Overview: Production error in version 1.0 harnesses; The immobilizer wire (orange/black) is in pin position #4 instead of pin position #5. Although an effort to correct the issue was made, some quantity of harnesses did get shipped before the issue was spotted. We are advising to inspect the harness BLADE connector before attempting to install harness or program the module. This issue is not known to affect the version 2 harnesses, which require no modification.

Descripción general: Las primeras versiones del arnés FTI-STP1 requieren modificaciones para aplicaciones de transmisión automática (AT), algunas del producto se pudo modificar antes del lanzamiento, pero una pequeña cantidad se lanzó sin modificaciones.

FTI-STP1: Notas de preparación y cobertura del vehículo

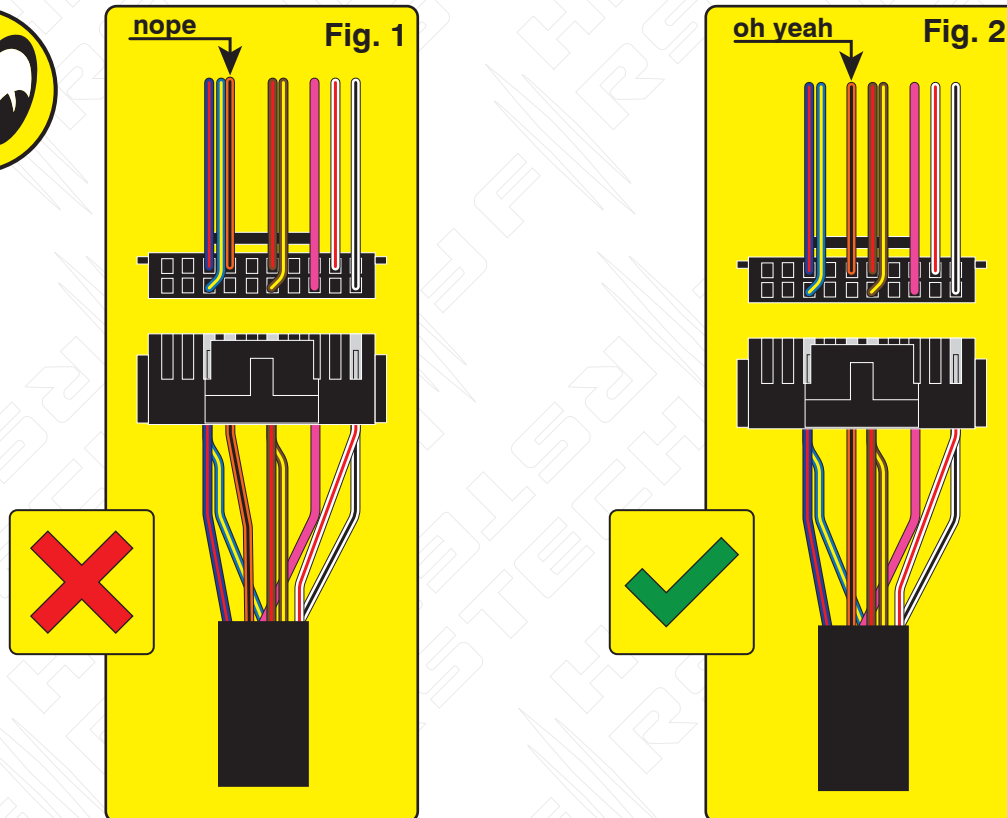
Issue: Module fails to program correctly to vehicle, does not allow the vehicle to be remote started.

Correction: Step 1.) Locate the orange/black wire and confirm whether it is positioned as illustrated in Fig. 1 or Fig. 2. If the wire is as illustrated in Fig.1, proceed with Step 2 through 5 and complete the repair procedure outlined, if the wire is as illustrated in Fig. 2, correction is not necessary, proceed with harness installation and module programming.

Step 2.) Using a pick, lightly depress the catch that secures the terminal in the housing then remove the wire and terminal from the housing.

Step 3.) Using a fine tip razor or utility knife, insert the blade beneath the terminal catch and raise it slightly, so that it can be reused to secure the terminal when reinserted into the BLADE connector housing.

Step 4.) Refer to Fig. 2 for correct position of the orange/black wire (next to brown/red) then reinsert the terminal, pressing lightly until the catch 'snaps' into place, securing the terminal in the connector housing.

Step 5.) The repair is complete, proceed with installation and programming.

MODIFICACIÓN REQUERIDA PARA APLICACIONES A/T, SÓLO CON ARNÉS v 1.0

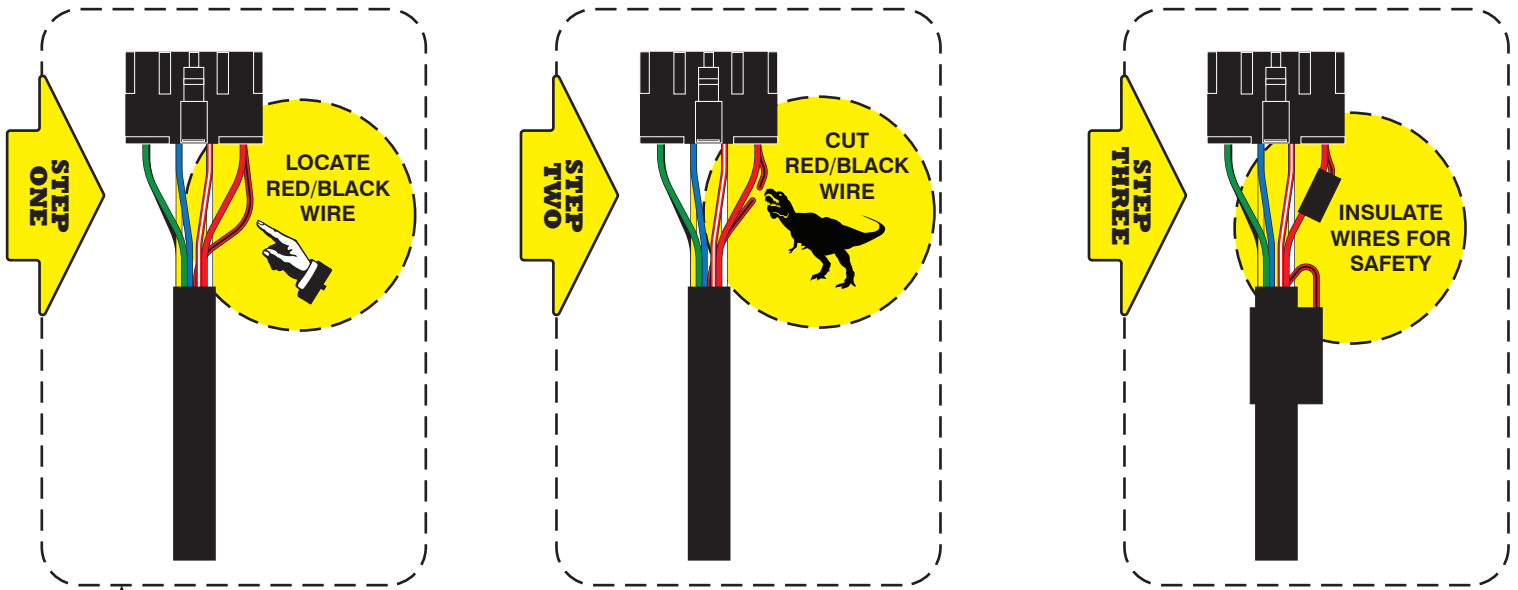
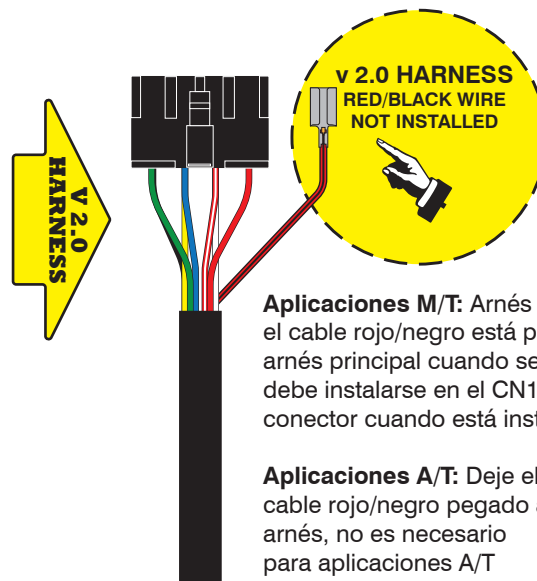
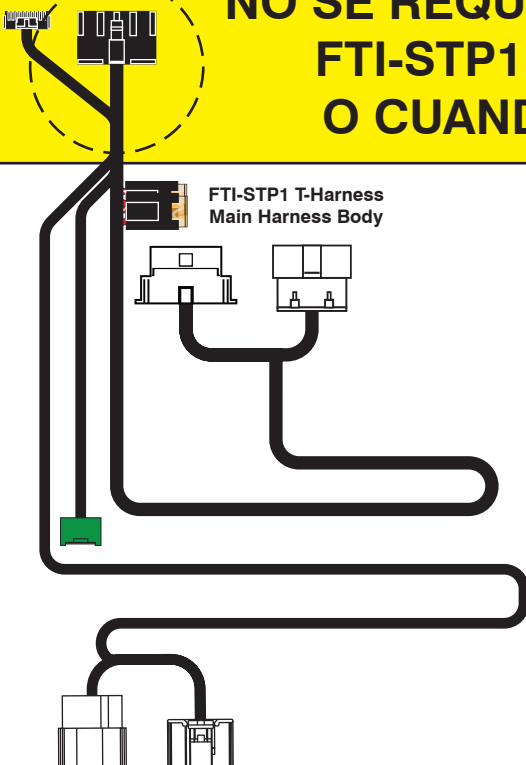
Problema: El arnés en T FTI-STP1 ha sido diseñado para ser compatible con A/T (transmisión automática) y M/T (manual transmisión), pero debido a un descuido en las primeras ejecuciones de producción, la selección se estableció por defecto en el modo M/T.

El uso de un arnés configurado para una aplicación M/T, en un vehículo equipado con A/T, podría provocar daños en el módulo del vehículo, se recomienda que el arnés vuelva al modo A/T antes de la instalación en vehículos equipados con transmisión automática.

Corrección: Localice el cable rojo/negro (+ embrague) proporcionado en el conector CN1 del conjunto del arnés principal. Corte el cable rojo/negro, ya sea al ras del conector CN1 o dejando suficiente cable expuesto para que pueda aislar y asegure los extremos del cable que quedan después del corte. Aísle cada uno de los extremos restantes del cable rojo/negro y asegúrelos para evitar cualquier posibilidad de cortocircuito. Si el cable rojo/negro ya ha sido desconectado, ninguna modificación adicional se requiere para aplicaciones A/T

NO SE REQUIERE MODIFICACIÓN CUANDO SE UTILIZA FTI-STP1 (v 1.0) ARNÉS EN APLICACIONES M/T, O CUANDO UTILICE EL ARNÉS FTI-STP1 (v 2.0)
